APPLICATION NO.	FILING DATE	FIRST NAMED INVENTOR	ATTORNEY DOCKET NO.	CONFIRMATION NO.
10/510,330	04/07/2005	Zmaj Petrovic	1429-143	8380

Office Action Summary

2. Claims 1 and 2 are rejected under 35 U.S.C. 102(b) as being anticipated by Garvey USP 4,401,207.

[54] PRODUCT ACCUMULATOR

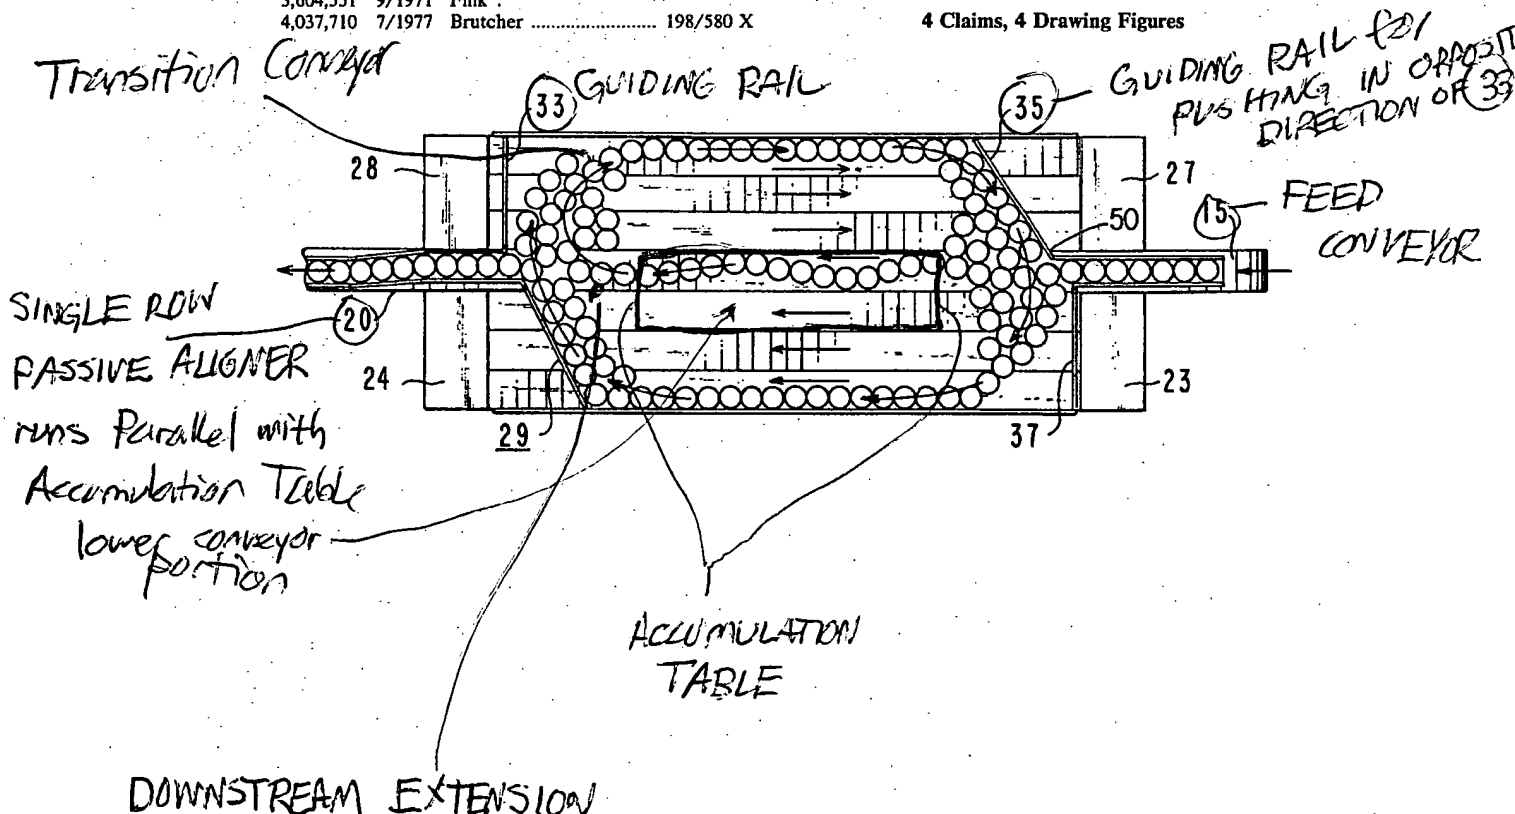
See the attached marked up cover sheet of Garvey depicting the claimed features.

FIG. 1

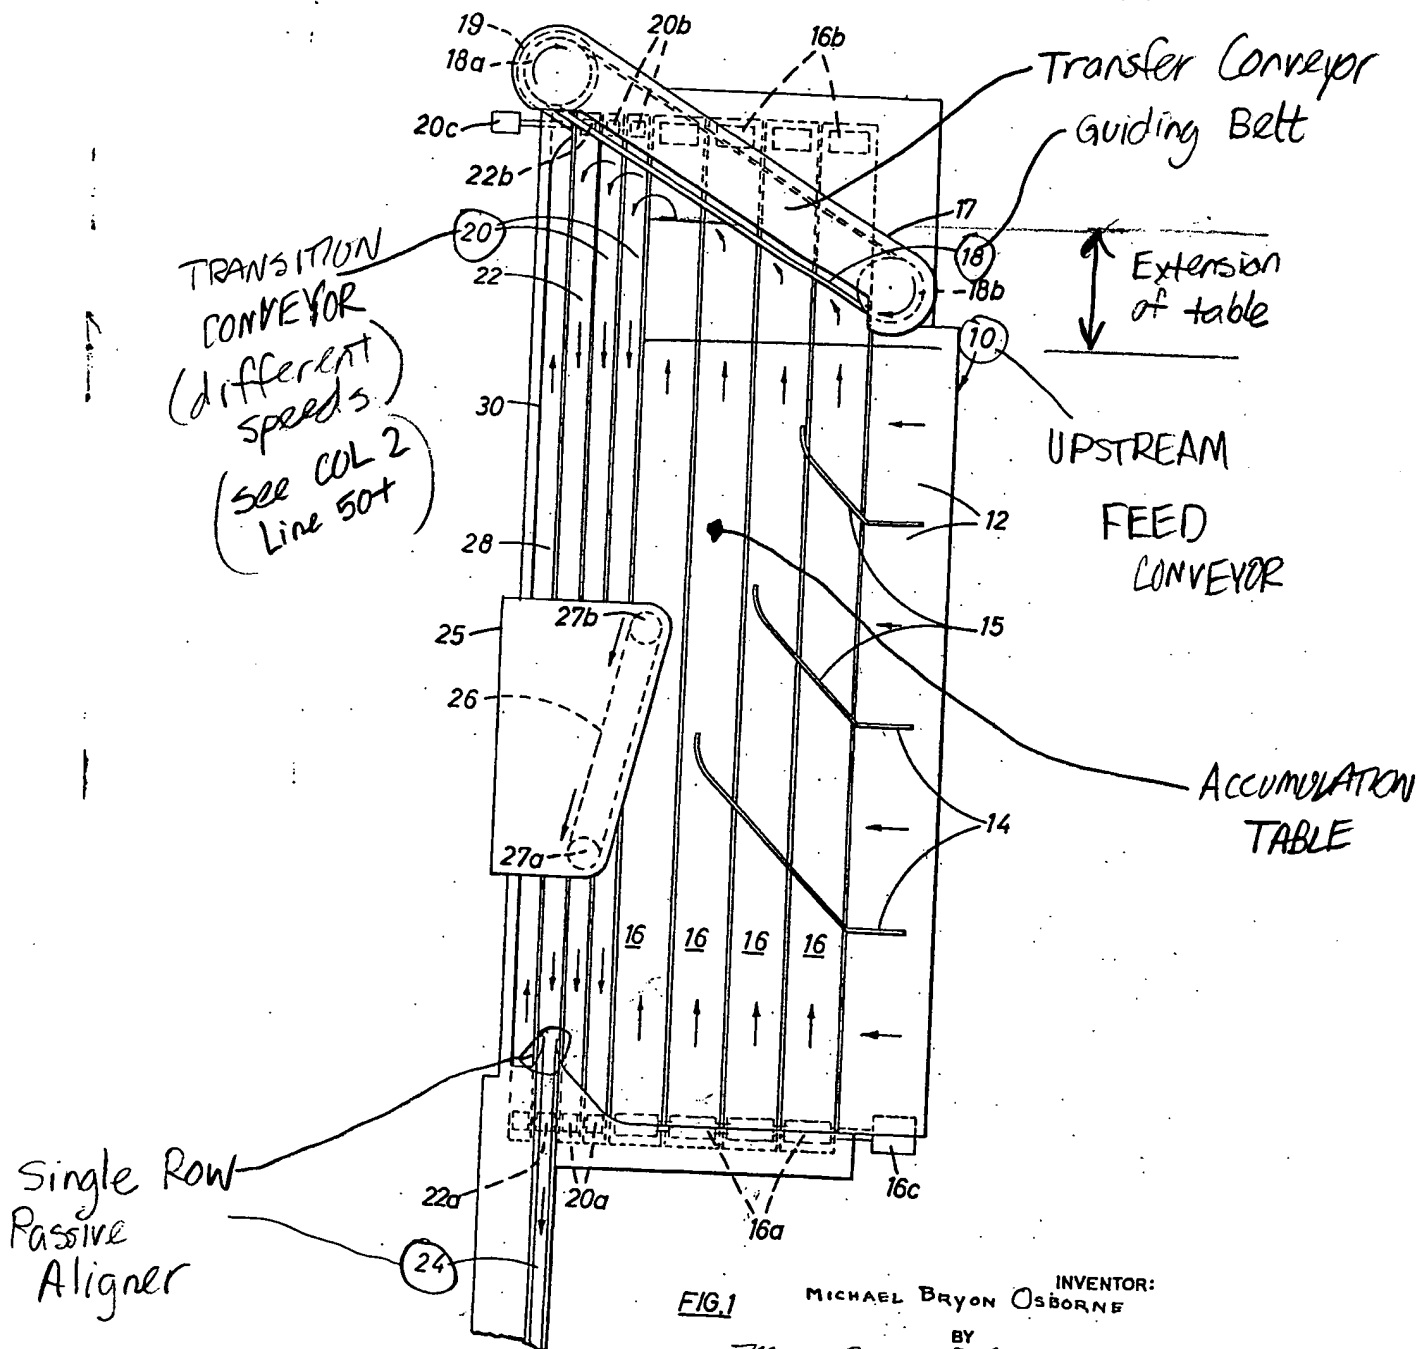
4. Claims 1 and 3 are rejected under 35 U.S.C. 103(a) as being unpatentable over Osborne USP 3,104,753 in view of Garvey (above).

Osborne teaches the claimed invention as shown on the attached marked up cover sheet.

Osborne utilizes a belt diverter instead of a guide rail diverter. It would have been an obvious

matter of design choice as to the type of diverter being used based on design characteristics, such as the articles being conveyed and their specific properties and their interaction with the conveyors. Garvey teaches a guide rail diverter. Substituting the guide rail diverter of Garvey for the belt diverter of Osborne would have been obvious for the reasons stated above.
